SUBJECT: Draft Final Technical Project Planning (TPP) Memorandum for the Remedial Investigation/Feasibility Study (RI/FS) at the Lower Camp Debris Site, Defense Environmental Restoration Program for Formerly Used Defense Sites (DERP-FUDS) Property No. I02PR0068, Culebra, Puerto Rico

Technical Project Planning Meeting Memorandum

Remedial Investigation/Feasibility Study

Lower Camp Camp Debris Site – Project Number
I02PR006800

Background - Sample Unit 3

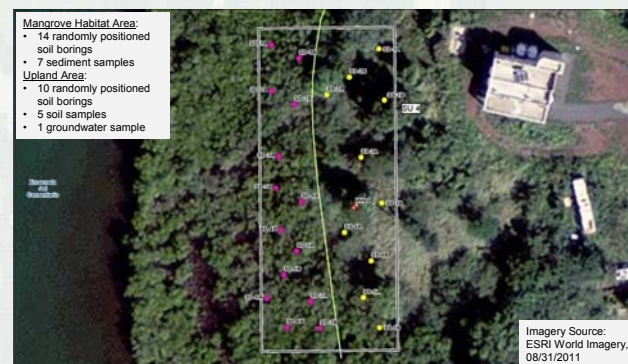
Diane Wehner/NOAA NOS asked what was located next to Sample Unit (SU) 5. Ricardo Colon/U.S. Fish and Wildlife Service (USFWS) and Ana Roman/USFWS clarified the buildings east and south of the SU were USFWS facilities and Authority of Conservation and Development for Culebra (ACDEC) buildings. Diane asked if anything upgradient from SU5 was draining to the SU. Bryan Burkingstock/CH2M said it is possible, but this area is a lower spot between to higher spots along a topographical ridge and overland flow would flow east and west from SU5. The SU5 area was unoccupied, grass covered open space from 1943 onward and no activities occurred in the area based on historical aerial photos. There is no indication of activities at SU3, SU4, or SU5 during DoD use.

Diane noted there were no discrete samples in the sample approach, and the USACE would need discrete samples for the screening level risk assessment (SLRA). In addition, Diane questioned the high number of samples and asked if composite sampling was appropriate. Decision unit (DU) and composite sampling would not be acceptable, because an average sample cannot be compared to a screening value. Therefore, a SLRA cannot be completed without discrete samples. Tom Georgian/USACE said the maximum value can be compared with screening levels and that one hit above screening levels does not indicate risk. Tom stated the dataset will have 15 concentration measurements with screening level exceedances compared to background. Diane stated if maximum composite is used, the worst case scenario cannot be measured. Diane recommended 15 discrete samples instead of 30. Tom stated it was more representative to composite 30 samples into 15 grabs. Katarina Rutkowski/TRC Inc./PREQB Contractor did not agree with compositing samples inside and outside debris piles to make a DU. Katarina supports taking more discrete samples or doing true incremental sampling. Katarina further stated she has not seen this approach used for a remedial investigation, does not agree with composite sampling, and wants the area where debris is located characterized as opposed to where the debris is not. Tom discussed the use of composites and Katarina suggested comments will be provided in the Uniform Federal Policy for Quality Assurance Project Plan (UFP-QAPP). Tom had no objection to getting a larger unit of grabs and recommended 15 to 30 samples if the technical approach is not to composite any samples. The tentative resolution is to collect 15 discrete samples.

Diane wanted to make sure SU3 and SU4 are appropriate as background if there are non-DoD-related activities upgradient from the sample units. Diane stated SU5 could be used for soil background, but the USACE needed to select a new location for sediment background. Lisamarie Carrubba/NOAA Fisheries stated SU4 was not background, as building septic effluent flows in that area. Diane stated the existing facility could impact SU4, and she did not want other input into background SU areas. Diane recommended removing SU4 completely. Katarina did not agree with using SU5 as a background area and recommended using only SU3 as the background SU. Tom pointed out that background is not necessarily natural, but just the background for site use in that area (anthropogenic background). Katarina asked whether a monitoring well could be installed between SU2 and the septic tank, and Wilberto stated the USACE needs to have an internal discussion to determine if this request is within the bounds of the contract and authorized area.
